MEMORANDUM

DATE: September 11, 2012

SUBJECT: **BZA Case 18404** – Request for Special Exception relief for a concrete manufacturing facility constructed at 3 DC Village Lane SW

Figure 1

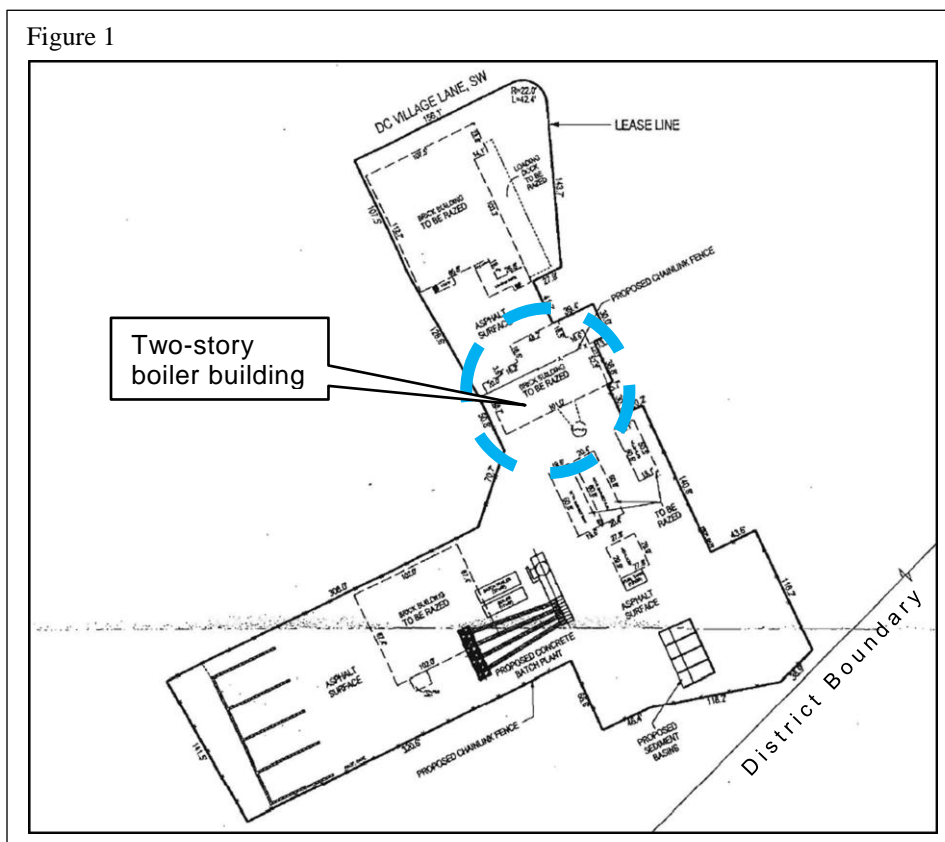
While the boiler building screens part of the site, the existing landscaping and fence are inadequate to screen the rest from the "public view" (the view from DC Village Lane). The chain link fence does not screen the plant at all and the current potted tree spacing negates their potential to effectively screen the site and parking area (refer to Exhibit 2).

The Pre-hearing Supplement indicates that an opaque covering would be added to fence portions in the "public view". Annotation on the attached landscaping plan indicated that opaque vinyl slats would be inserted into fence sections immediately north and east of the plant.

Screening just those borders is acceptable to OP because the other boundaries face other industrial uses and the MPD impound lot.² Since vinyl slates tend to fall into disrepair

over time, OP recommends the use of continuous vinyl mesh instead.

- This special exception approval shall expire **7 years** from the publication date of the final Board of Zoning Adjustment (BZA) order.
- Continuous opaque vinyl mesh shall be added to sections of chain link fence to the north and east of the concrete manufacturing facility.
